## ADDENDUM NO. 4

Reference: Ice Sheet Addition  
Weber County/WSU – Ogden, Utah  
DFCM Project No. 12265810

The Ice Sheet Addition  
4390 Harrison Blvd.  
Ogden, Utah

DFCM Project No. 12265810  
FFKR Project No. 11124

1 REFRIGERATION ROOM PLAN  
R401 SCALE: 1/4" = 1'-0"  
0' 4' 8'

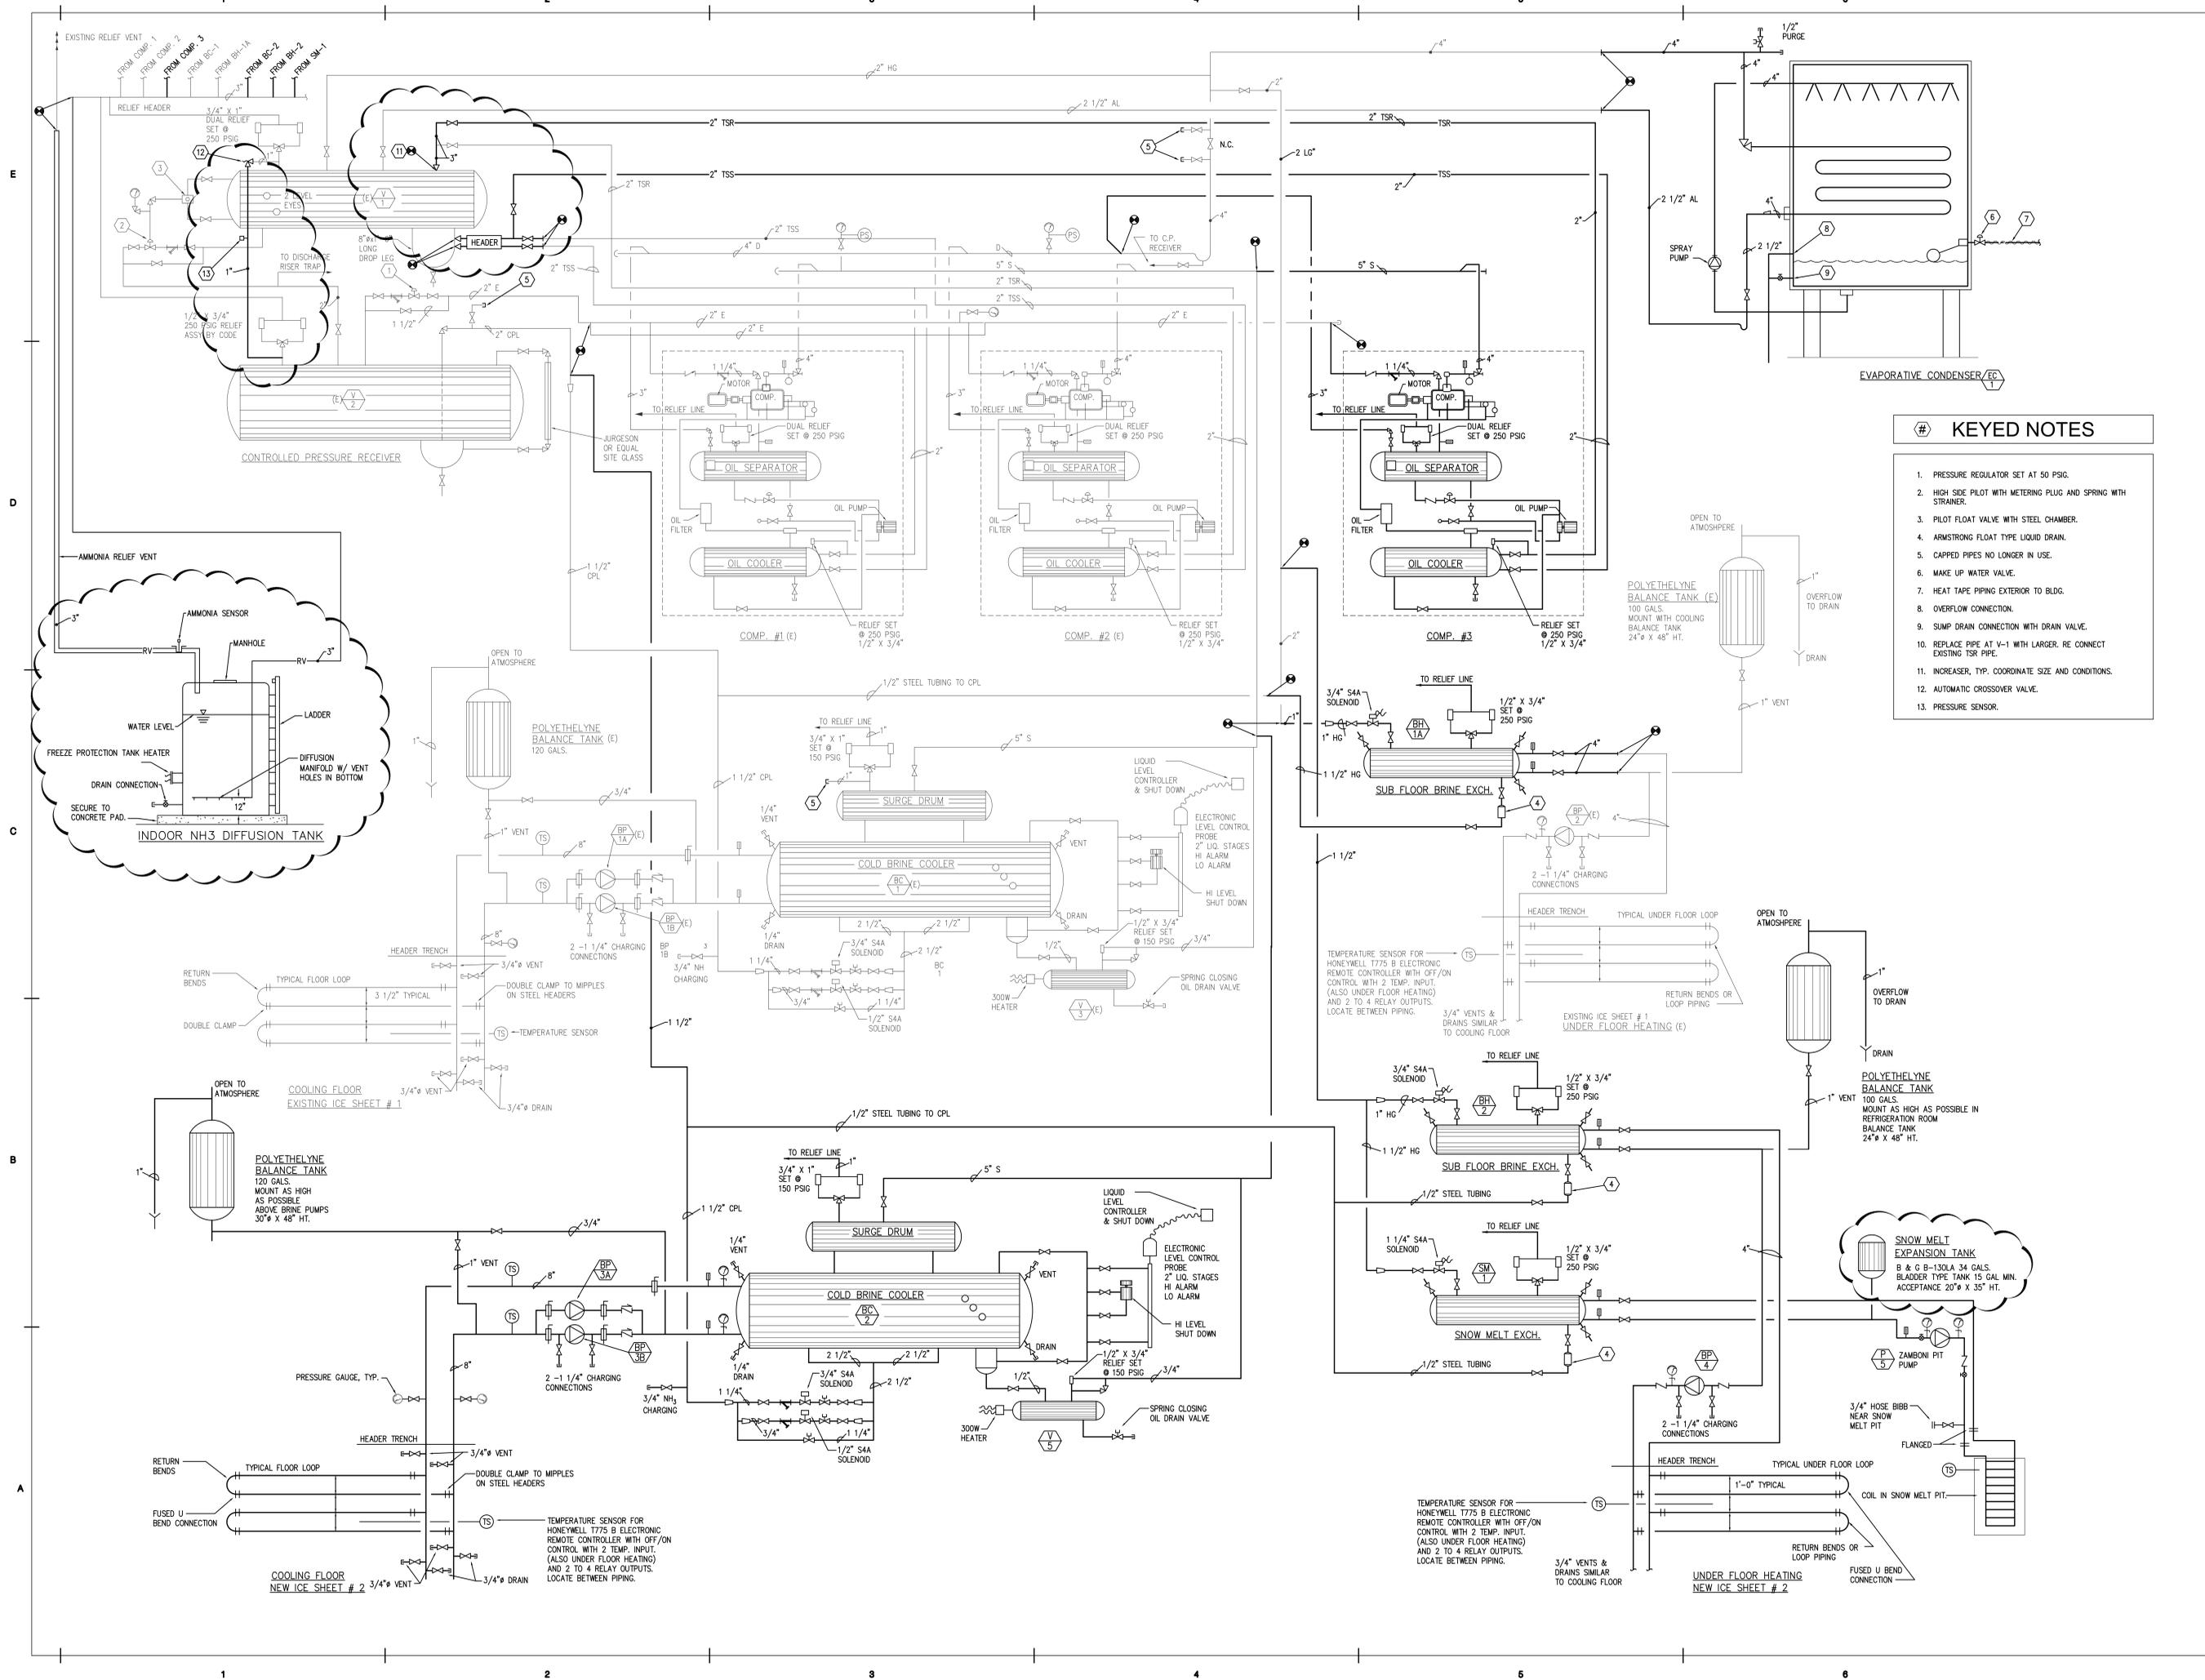
SHEET R401 – REFRIGERATION PLAN – Re-issued

1 ELECTRICAL SITE PLAN  
ES101 SCALE: 1"=20'-0"  
0' 20' 40'

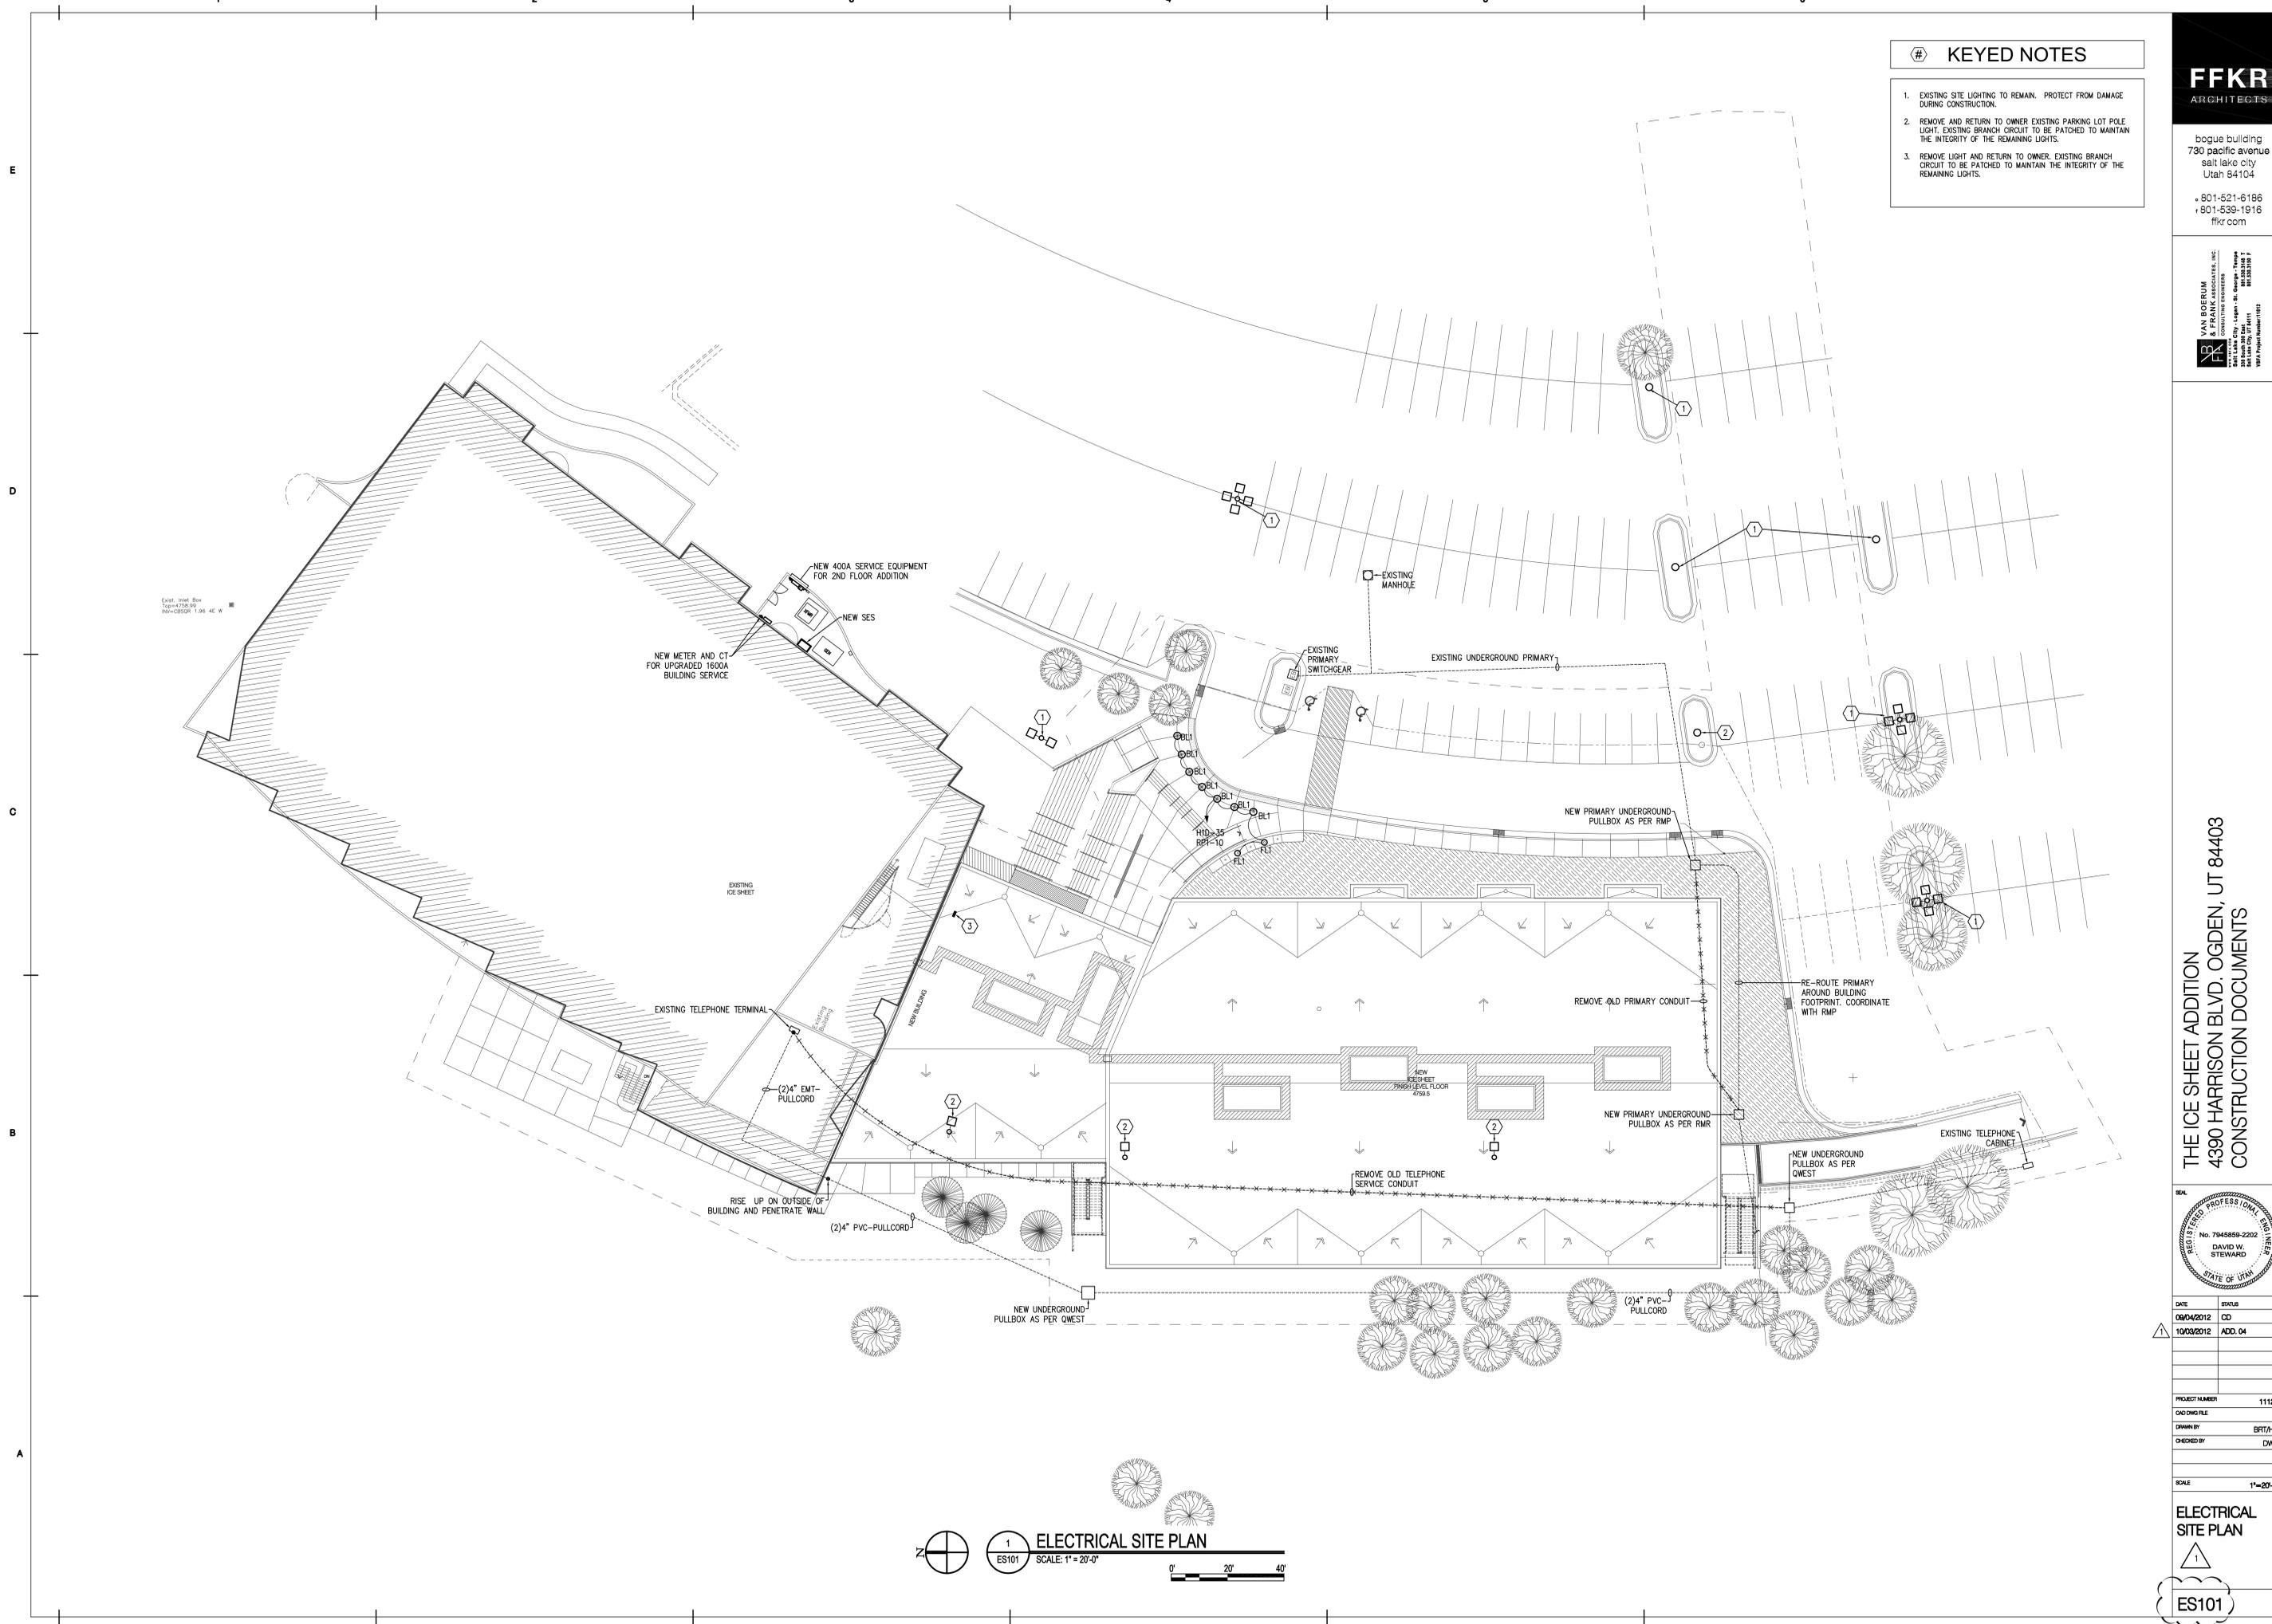
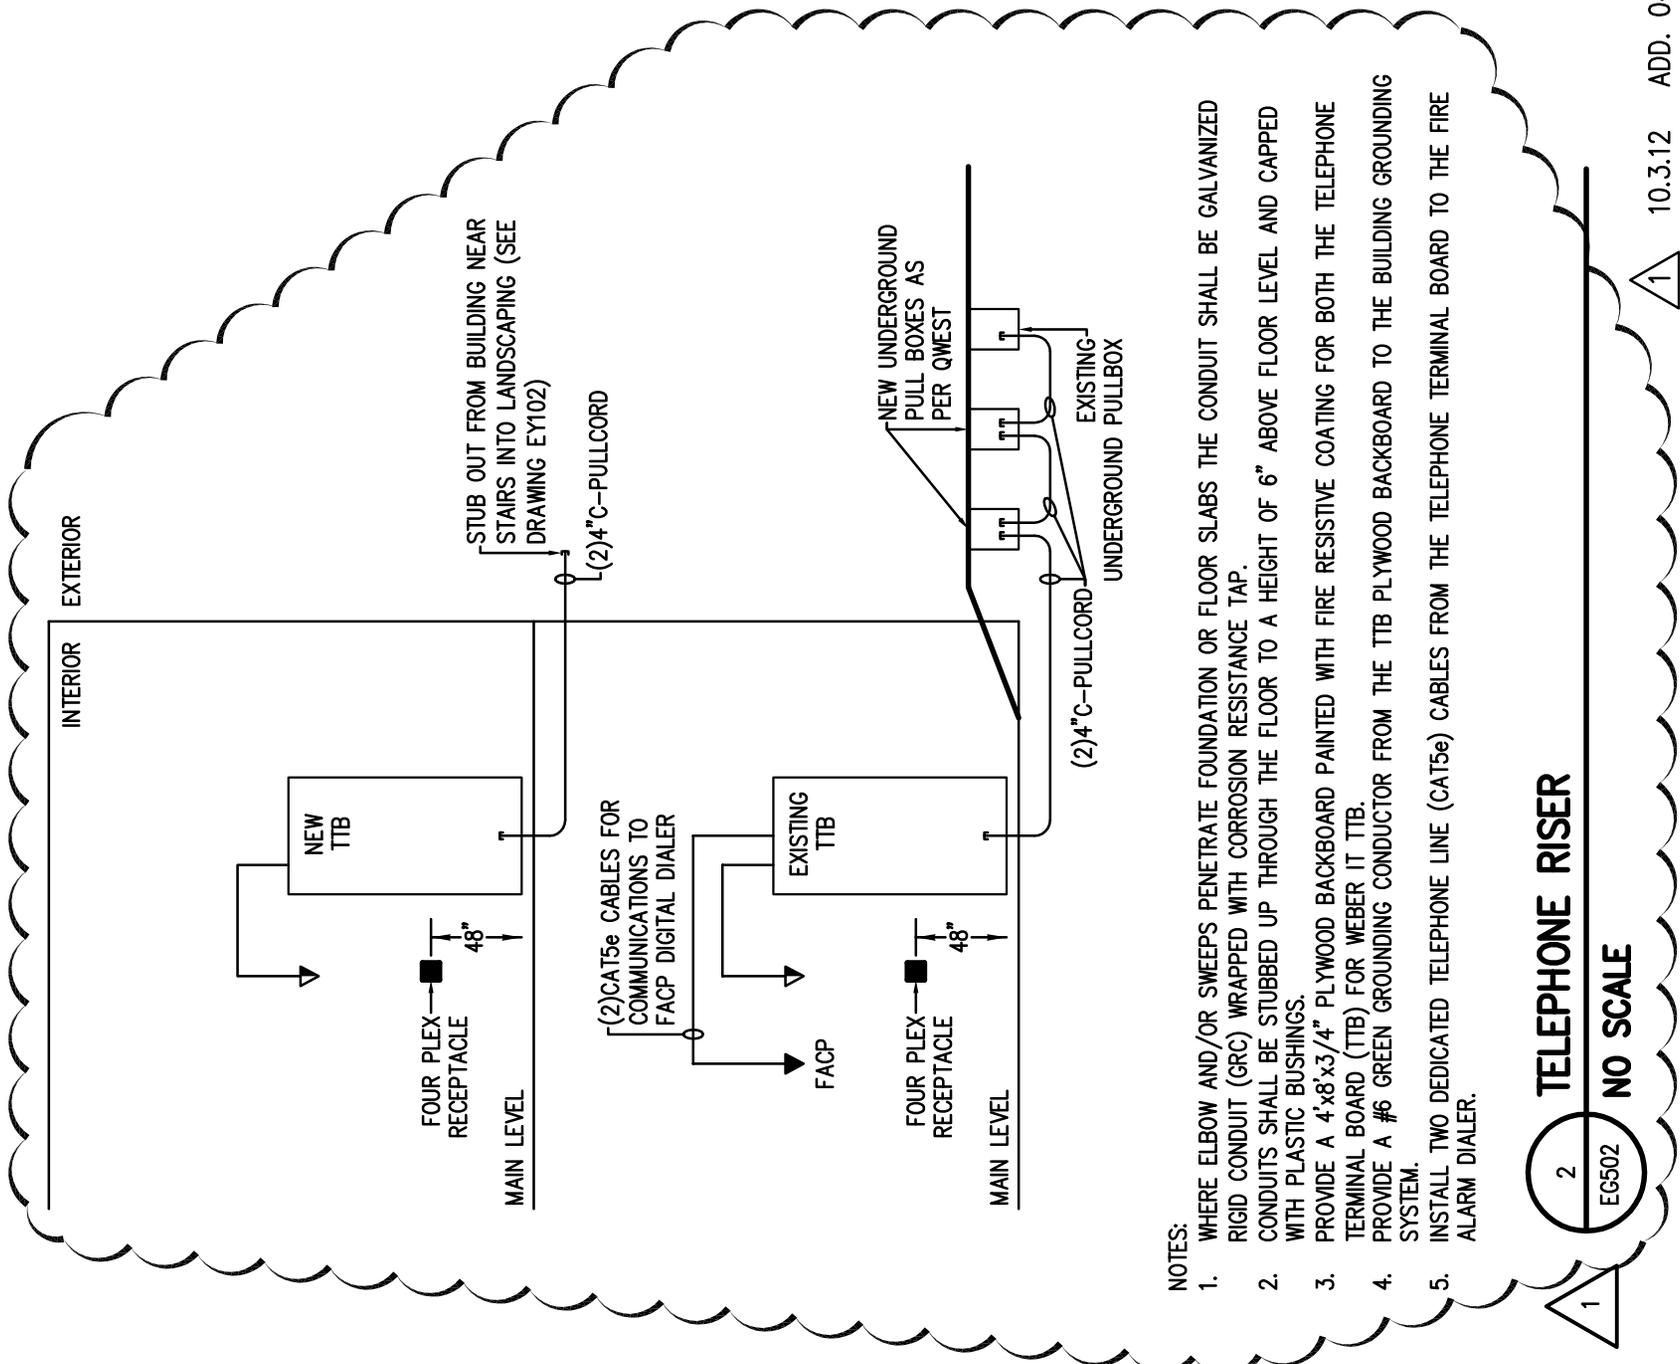
#### SHEET - ES101 – ELECTRICAL SITE PLAN

1. Replace the existing electrical site plan with the new attached site plan.
2. The existing underground primary will need to be routed around the new building footprint as shown on the revised site plan. Coordinate with Rocky Mountain Power for location of new pull boxes and new primary conduit requirements.
3. The existing telephone service conduit will need to be re-routed around the new building footprint. Install two new pullboxes (as per Qwest requirements) and (2)4"C-pullcord as shown on the revised site plan.
4. The new electrical distribution equipment in the electrical courtyard has been better identified on the revised site plan for the contractors coordination.
